Access Compliance Report

Public Rights-of-Way

Intersection ID: 30541	Main Street: GREENWAY_BEND_DR	Cross Street: SUMMERHILL_RIDGE_DR	Location: SE
ADA ID: 8281151C1A1D	Ramp Type: PerpDiag	Initial Pass/Fail: Fail	Overall Compliance: No
Codes/Mitigation Info/Possible Solution		Field Measurements/Component Compliance

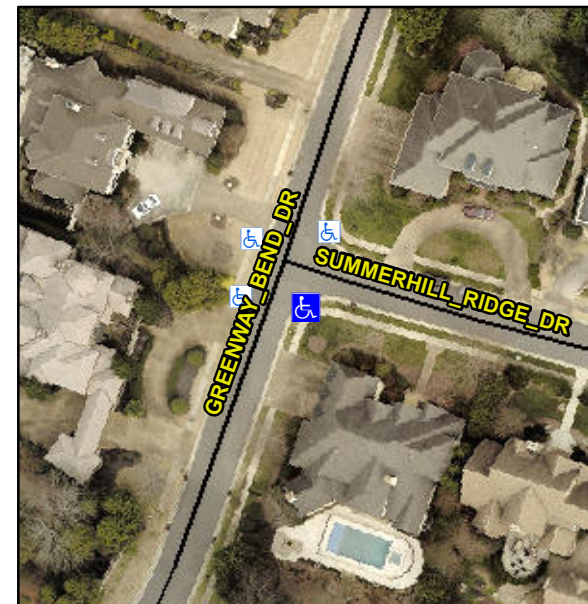
Not Found, R304.2.2, R304.5.3

Compliance	Description	Data	Compliance	Description	Data
N/A	Ramp Length (in)	48.0	No	Ramp Slope (%)	9.3
Yes	Ramp Width (in)	49.0	No	Ramp XSlope (%)	3.7
N/A	Flare Type LT	N/A	N/A	Flare Type RT	N/A
N/A	Flare Slope LT (%)	N/A	N/A	Flare Slope RT (%)	N/A
N/A	Flare Traversable LT?	N/A	N/A	Flare Traversable RT?	N/A
N/A	Landing Length (in)	N/A	N/A	DWS Provided?	N/A
N/A	Landing Width (in)	N/A	N/A	DWS Contrast?	N/A
N/A	Landing Slope (%)	N/A	N/A	DWS Length (in)	N/A
N/A	Landing X Slope (%)	N/A	N/A	DWS Full Width?	N/A
N/A	Landing Curb? (Y/N)	N/A	N/A	DWS Offset (in)	N/A
N/A	Shared Landing?	N/A			
N/A	Gutter Ponding?	N/A	N/A	Gutter Slope (%)	N/A
N/A	Gutter Lip Ht (in)	N/A	N/A	Gutter X Slope (%)	N/A
N/A	Painted X Walk1?	No	N/A	Painted X Walk2?	No
	X Walk 1 Direction	To NE		X Walk 2 Direction	To NW
N/A	X Walk 1 Width (in)	N/A	N/A	X Walk 2 Width (in)	N/A
	X Walk 1 Slope (%)	4.9		X Walk 2 Slope (%)	2.3
	X Walk 1 X Slope (%)	0.0		X Walk 2 X Slope (%)	2.3

Remove & Replace Curb Ramp With Two New Directional Ramps or Equivalent.
